CITY OF ALBUQUERQUE

November 13, 2019

RE: **Lot 5A & 5B 2619 Corianda**
Grading Plan Stamp Date: 10/29/19
Drainage File: G13D023D

ENGINEER'S SEAL  10/29/19	LOT 5-A AND 5-B CORIANDA GRADING AND DRAINAGE PLAN  <i>Rio Grande Engineering</i> 1606 CENTRAL AVENUE SE SUITE 201 ALBUQUERQUE, NM 87106 (505) 872-0398	DRAWN BY: WCVJ
		DATE 10-29-19 2109086-LAYOUT-10-29-19 SHEET # — JOB # 2109086

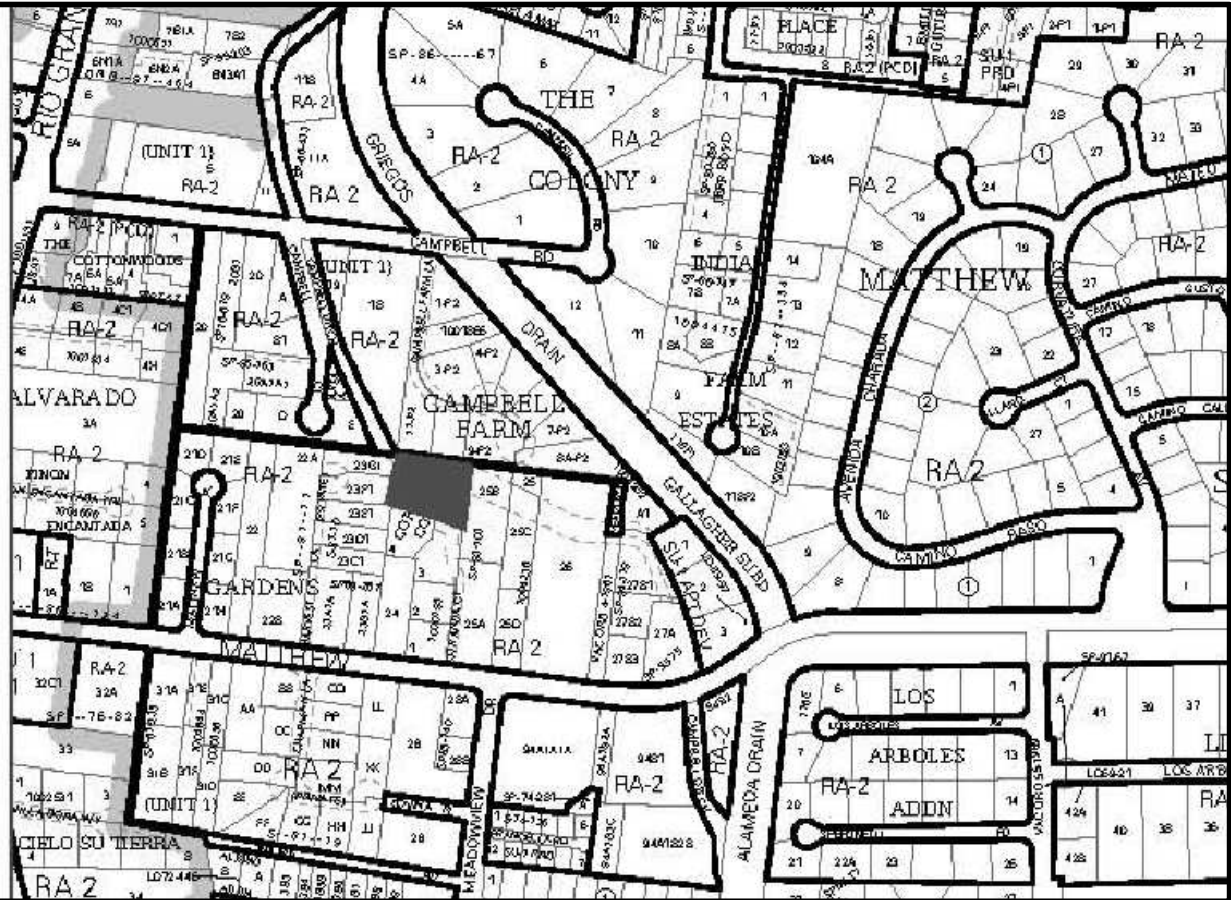
1. Provide a cross lot drainage easement between the proposed lots; name maintenance responsibility and beneficiary.
2. Provide a drainage easement over the proposed pond and annotate using the Plat Drainage Easement Note as found on the Hydrology website.

3. Engineer's Certification of the compacted pad (Pad Certification), per the DPM Chapter 22.7: *Engineer's Certification Checklist For Subdivision* is required.
4. The Plat must be recorded (unless paper easements in lieu of the above easements have been granted/recorded).
